UNITED STATES PATENT AND TRADEMARK OFFICE

10/023,474

Office Action Summary	Application No. 10/023,474	Applicant(s) LIANG, LUKE K.	
	Examiner CARLOS LUGO	Art Unit 3673

DETAILED ACTION

Attachment #1

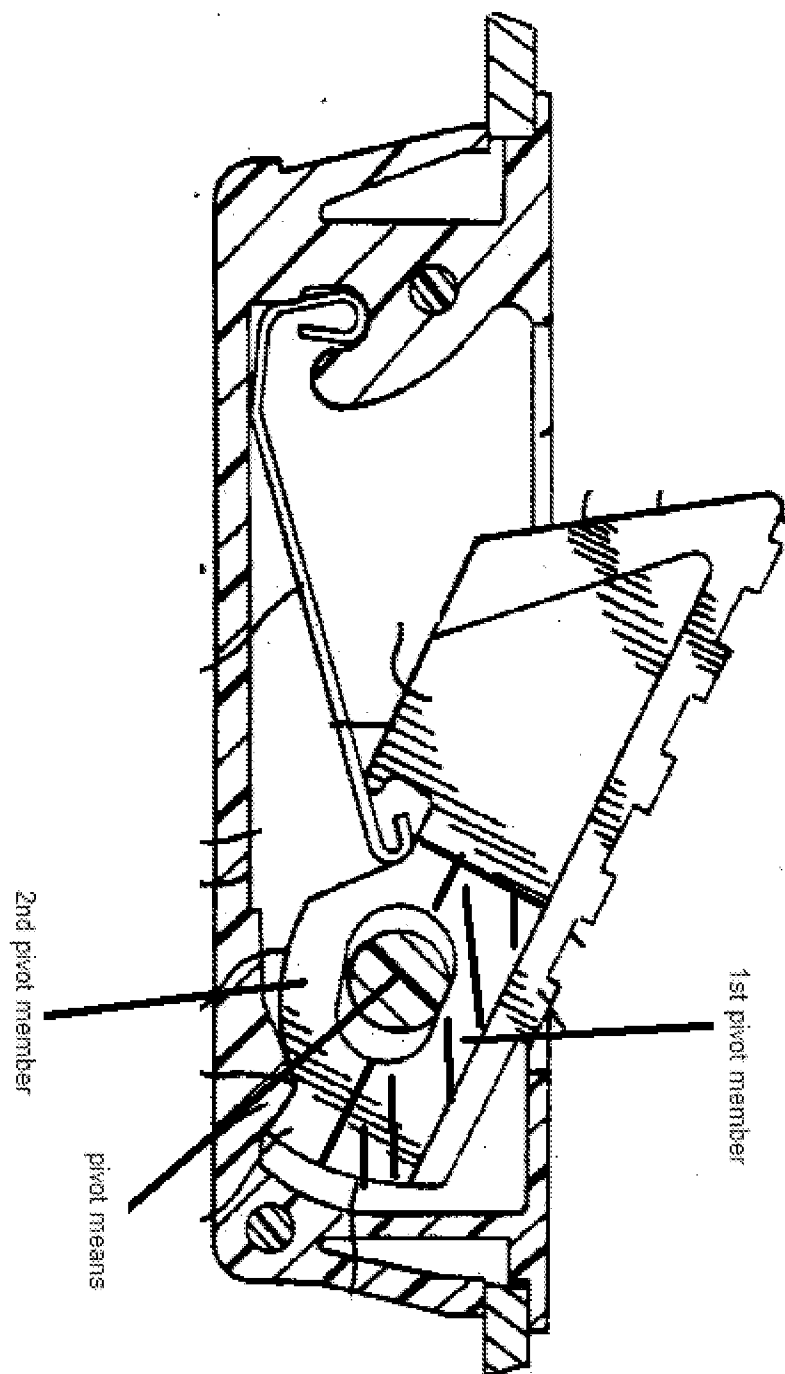
The tumbler further comprises a first pivot member that is capable of being in contact with the pivot means (38) when the tumbler is in the extended position (Figure 6, the opening contact the surface of 38), and a second pivot member that contact the bottom surface of the housing to prevent over travel of the tumbler (see attachment #1).
